#### **ZONING AMENDMENT STAFF REPORT** Date: November 15, 2007

**LOCATION** 64 Tacon Street

**CONTEMPLATED USE** Rezoning from R-1, Single Family Residential, to B-1,

# 26 ZON2007-02563

# PLANNING COMMISSION VICINITY MAP - EXISTING ZONING

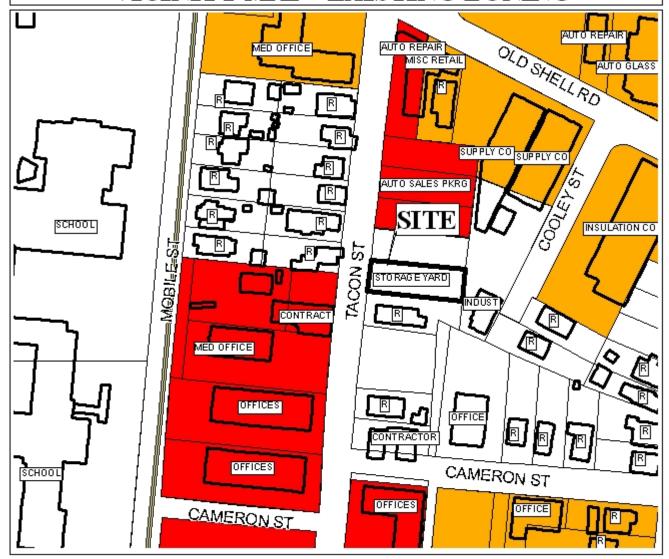
The site is currently an undeveloped 7,800 square foot single-family residential lot. The applicant proposes to move an 8-foot x 18-foot (144 square foot) temporary office, and provide eight gravel parking spaces. However, the Vicinity Map illustrates the site as a storage yard, which is not a legal use within an R-1, single-Family or a B-1, Buffer Business District.

## SITE PLAN

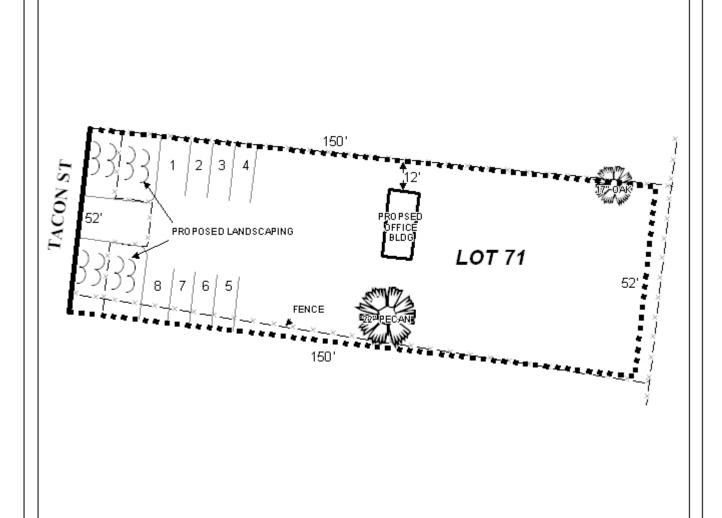
<u>COMMENTS</u> Driveway number, size, location, and design to be approved by Traffic Engineering and conform to AASHTO standards. No dimensions are shown on the site plan. The developer should insure that the driveway and parking aisle meet the minimum standard of twenty-four feet.

The site plan depicts the site improved with gravel parking and access, including 8 parking spaces, an entry from Tacon Street. The parking calculations on the site plan show that only 1 space is required for the proposed square footage of the temporary office. At a minimum one could assume that 1 space would be required (1 space per 300 square feet of office space), 8 spaces would be required for a 2,400 square foot office, at a parking ratio of 1 space per 300 square feet of floor space. Thus more information is required to determine if eight parking spaces would be needed for the proposed use. Also, it appears that the parking surface, parking stalls and maneuvering areas do not meet the minimum standards of the Zoning Ordinance. As the site plan submitted is not dimensioned, it is impossible to verify.

Regarding the landscaping calculations, it appears that sufficient *area* will be available for landscaping to meet the minimum requirements of the Zoning Ordinance. The site plan does not, however, depict the actual placement of heritage and understory trees required to depict full compliance.

The site plan does not indicate the location of a dumpster or other private waste facility, thus the site plan should be revised to depict the dumpster location. The location, furthermore, should be located away from adjacent residential uses, not only in terms of protecting residences from offensive odors, but also from the noise of the dumpster being emptied during the day or night.

The proximity of a B-1 district next to residential districts will require the provision of buffering, which in this case would likely have to be a 6-foot high wooden privacy fence and 3-foot high solid hedgerow along Tacon Street to screen the parking area from the adjacent residential zoning across Tacon Street. The site plan should reflect the required buffering.

New development normally requires the provision of a sidewalk along the adjacent public right-of-way, therefore a sidewalk should be shown on any future site plans, should the rezoning be approved.
